PERMIT

SEWAGE DISPOSAL SYSTEM
HOWARD COUNTY HEALTH DEPARTMENT
BUREAU OF ENVIRONMENTAL HEALTH
410-313-2640

P 513681

SUBDIVISION Wellington West II LOT NUMBER 28 ADDRESS 15324 Doe Hill Court

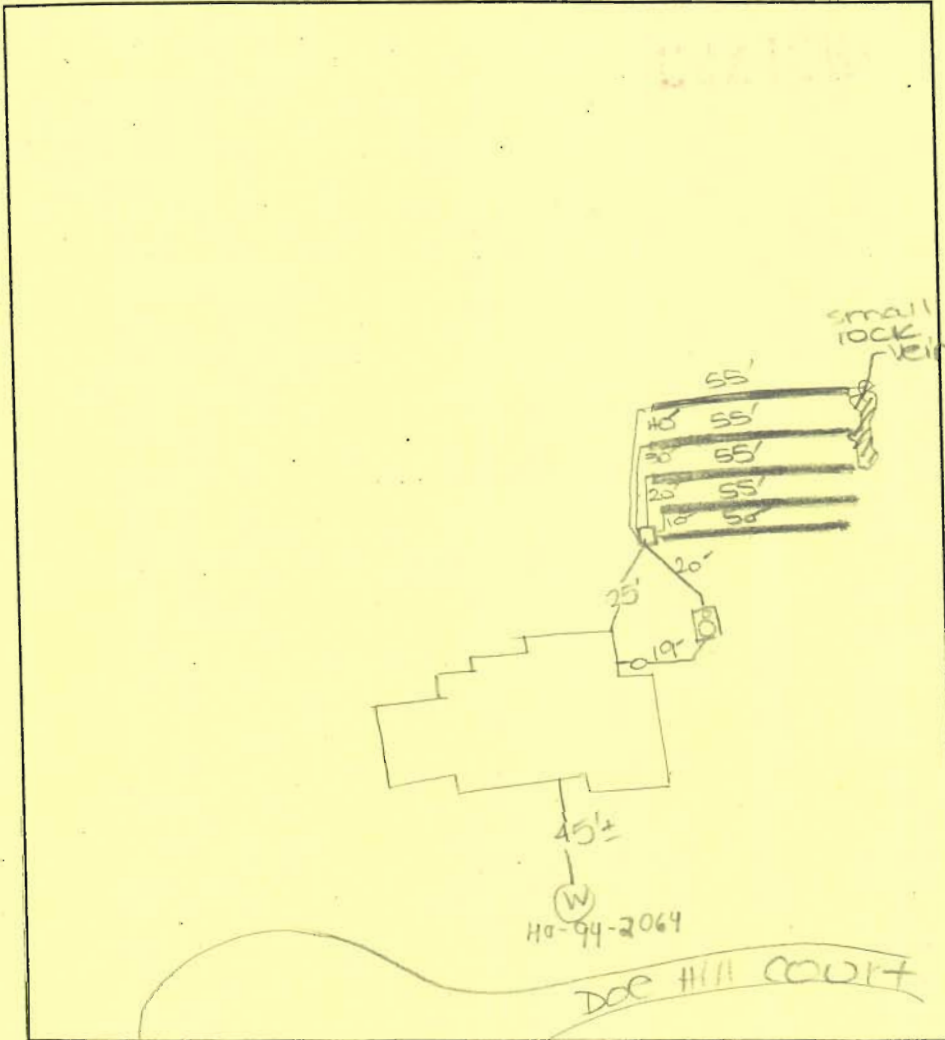
INSPECTION COMMENTS: 7/28/00 AM. Needs house connection.
OK to continue work. Rock encountered @ ends of 3 lower
trenches. Specs altered based on perc notes.
OK to continue work. DKS
7/28/00 P.M. Needs house connection. OK to cover
all septic work. DKS 8/18/00 House connection made. (B)
